SPARTAN CHASSIS, INC.

TSB07-210-001

TECHNICAL SERVICE BULLETIN

- SUBJECT:** Frame - Cab Mounting
- APPLIES TO:** Certain Spartan Firetrucks with a VDM (Vehicle Date of Manufacture) of May 23, 2001 through March 15, 2007.
- CONDITION:** Cab mount to frame fasteners are failing

FIG. 2-1

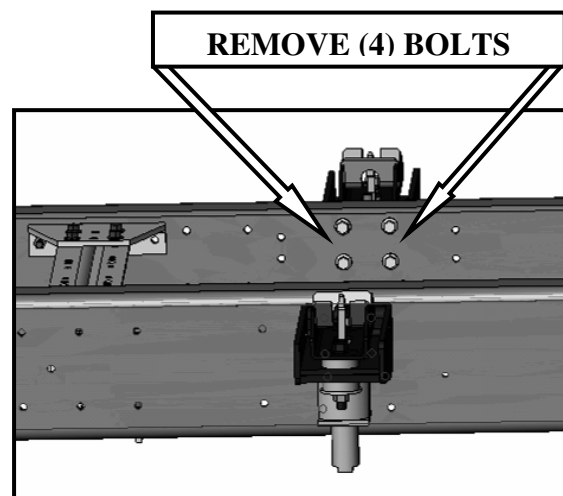
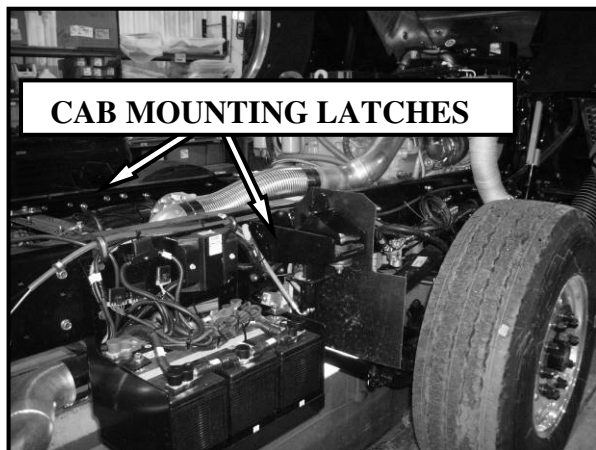
1. Observe all industry safety standards and secure vehicle for removal and installation of cab mount isolated latch.
2. Tilt cab and insure safety bracket is engaged.
3. Refer to FIG. 2-1. Locate and remove cab mount isolated latch assembly, save assembly and spacer for reuse. Discard fasteners.
4. Enlarge the four (4) mounting holes to 19/32" or .594 on the assembly and spacer if present.

5. Enlarge the four (4) holes to 19/32" or .594 on the frame rail.
6. Reinstall the assembly and spacer, insuring the spacer is between the assembly and frame rail, using the fasteners supplied in the kit. Torque to 95 ft. lbs.

NOTE: Fasteners must be installed from the inside of frame-rail to the outside of frame-rail.
